SERVICE BULLETIN

Service Bulletin No.: DAC1-34-02 Rev. 2

Title: Installation of backup Artificial Horizon Indicator

Figure 16

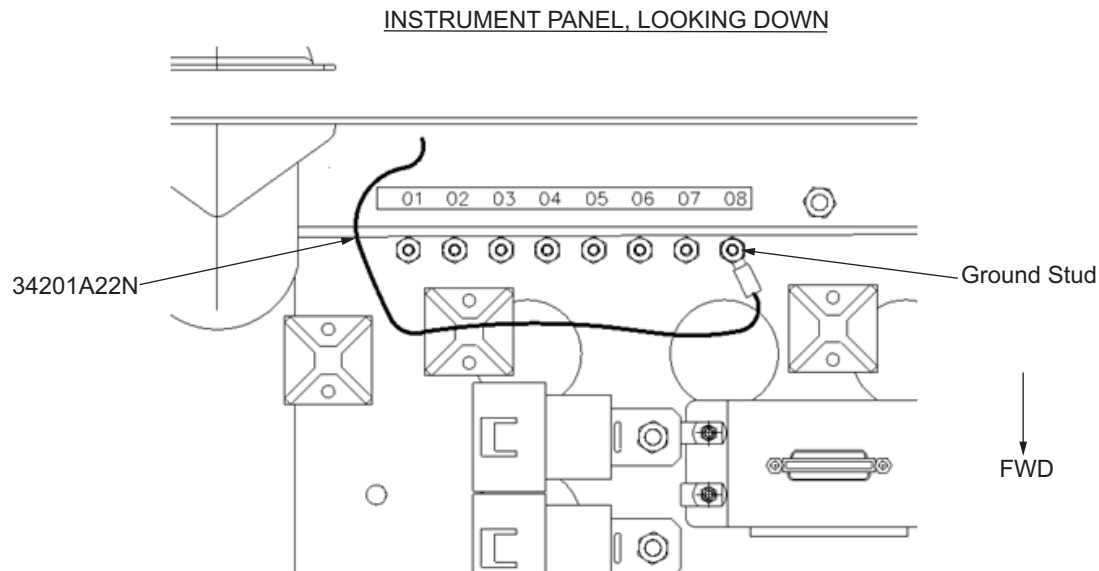
- 10.21 Connect the wire 34201A22N to ground stud #8 and secure with the supplied cable ties (P/N MS3367-4-9). Refer to Figure 16.
